## Administrative Staff Report

**Project Name:** Silver View Apartments Hearing Examiner Remand and Appeal

**Type of Application:** Type-II Administrative Conditional Use Permit

**Permit Number:** 18-00731 (HE Administrative Appeal 20-04126)

### Diagram of Pedestrian Improvement Frontage improvements

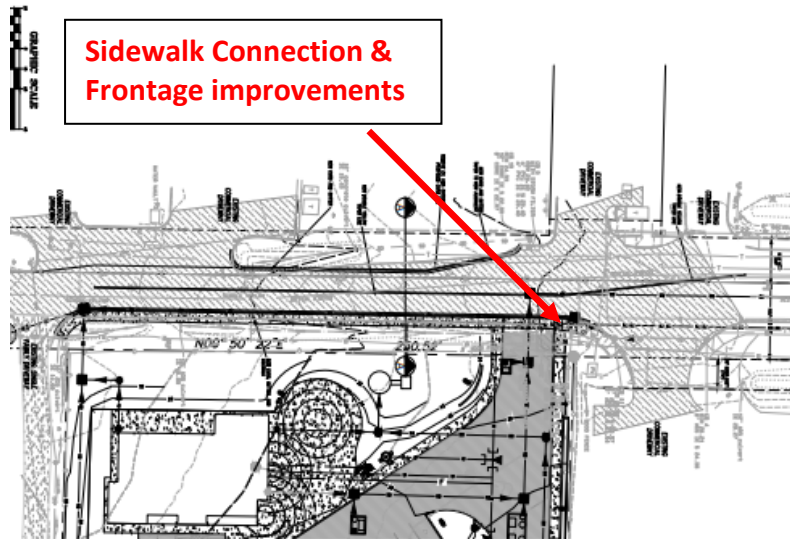
The project was reviewed for potential pedestrian and vehicular traffic impacts, which included analysis of adjacent intersections to monitor the vehicular level-of-service. There are property frontage improvements required along Mickelberry Road NW consisting of an 11-foot travel lane and 5-foot sidewalks. (Please see Condition 35).

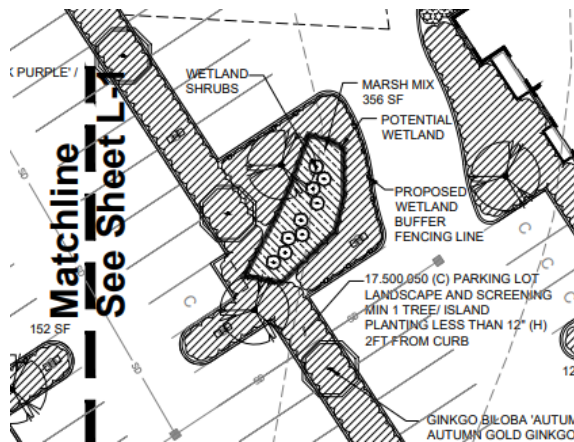
The project proposes to collect and convey stormwater runoff from the site west along the main access road to a diversion structure near Mickelberry Road NW. The diversion structure will convey the minimum required by code to a cartridge style filter system which will provide water quality mitigation. The portion of stormwater runoff, beyond the water quality requirement, will be diverted to a stormwater vault/pump station. Stormwater from the cartridge style filter system will discharge into the stormwater vault/pump station where all stormwater from the developed site will be pumped to the storm drainage conveyance system located at the intersection of Mickelberry Road NW and NW Bucklin Hill Roads. According to the owner of the project the County has designed the storm drainage conveyance system located in NW Bucklin Hill Road to convey the under-drained stormwater discharge from this project. Storm water discharge to the County system is anticipated to be without detention. Except for providing amended soils, the project is not proposing the use of any other LID BMPs due to the perched groundwater table and inability for onsite infiltration/dispersion. The geotechnical report does not recommend infiltration as an option for this site. The majority of the project's stormwater runoff is proposed to be collected, treated, and conveyed via a system of catch basins and pipes to an existing storm system located in NW Bucklin Hill Road; this existing storm system empties into Dyes Inlet at the same location where Clear Creek flows into Dyes Inlet. The remainder of the project site runoff will be collected treated and conveyed to a natural discharge point at the southwest corner of the site (see Attachment - B).

**Colored Site Plan – Project layout**

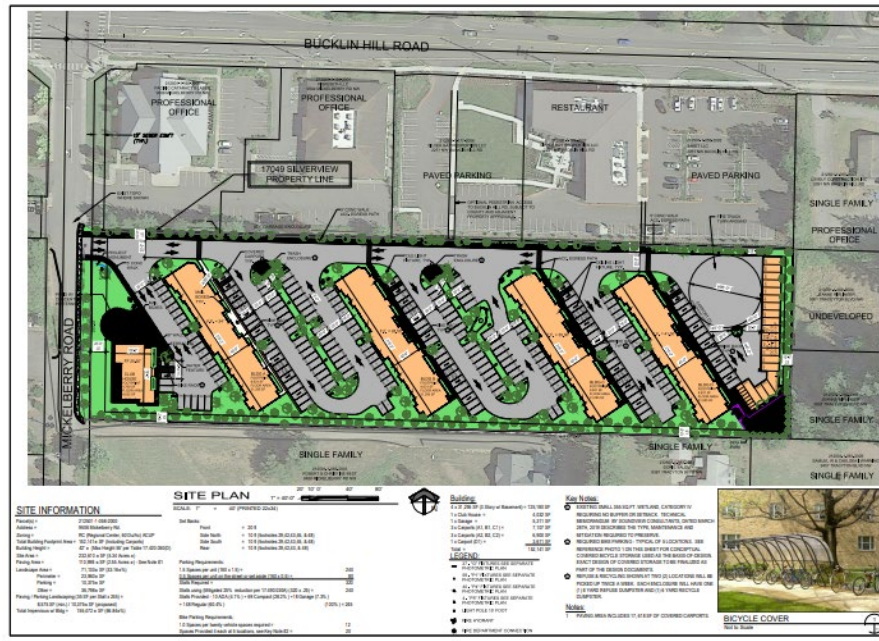
HE Comment: Per the Hearing Examiner Finding #16, the project site plan and narrative do not demonstrate compliance with the Silverdale Design Guidelines Section 9.4.3A., requiring parking to be oriented to the side or rear yard. Mr. Adams detailed how the project does not comport with the Design Standards. The Design Standards (and Comprehensive Plan) require the project to be respectful of single-family development (see Comprehensive Plan LU Goal 1 and Policy 1) (*See design standards -Revised Architectural Narrative Response to County Comments, July 15, 2022*).

*Staff Response: Staff concurs the project can operate as a transitional use between the more intensive commercial uses along Bucklin Hill Road to the north within the RC zone and provides a separation between the UR zone and associated single-family homes. The site plan shows the more intensive activities such as off-street parking adjacent to the RC zone. The building profiles show the apartment building stepped down with a screening buffer along the south and east property lines which reduces impacts to the Urban Restricted zone.*

Attachment B - Storm Drainage Conveyance Map (C3.0 Civil PLANS)

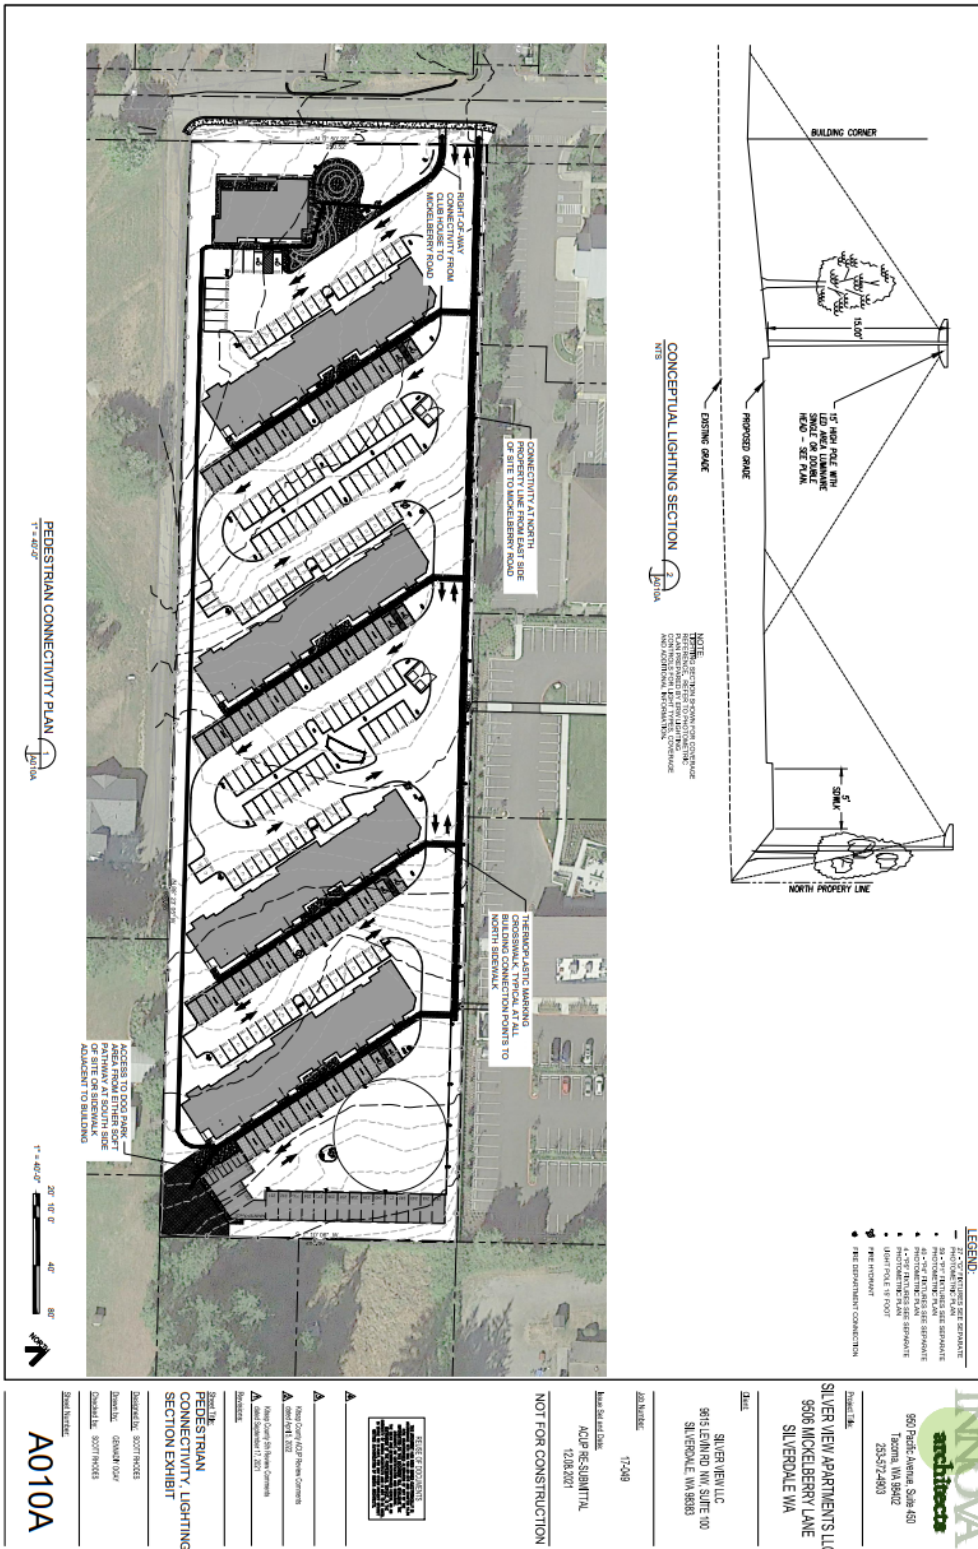
**HE Comment:** Infrastructure “viability” is a pre-requisite to ACUP approval and must be addressed in the environmental review. The County Stormwater Manual states, “[p]erforming a comprehensive inventory analysis is an essential first step to site assessment and planning and must precede site design.” This was not disputed. Further detail will be provided during Site Development Activity Permit Review per KCC Title 12 and building permit review, but system viability must be present at the land use review (ACUP and SEPA) stage. The above discussion addressed discharge to the north. There are also issues with the southern discharge point. This runoff will discharge on neighboring properties and run down to the lagoon and Dyes Inlet. Untreated runoff has the potential to significantly affect these resources. Dr. Cooke detailed stormwater impacts on estuary or off-site wetlands and the lagoon, noting concerns about lack of treatment for street runoff, including from heavy metals and petroleum hydrocarbons. Stormwater runoff is an issue susceptible to mitigation, but the impact must be first identified, and mitigation determined.

*Staff Response: Staff concurs that the applicant has provided additional analysis which exceeds the 60% design margin supporting conveyance to the north to Bucklin Hill Road, metered storm drainage to the wetland and conveyance of existing flows off-site to the southwest corner of the project site (see Attachment - B).*
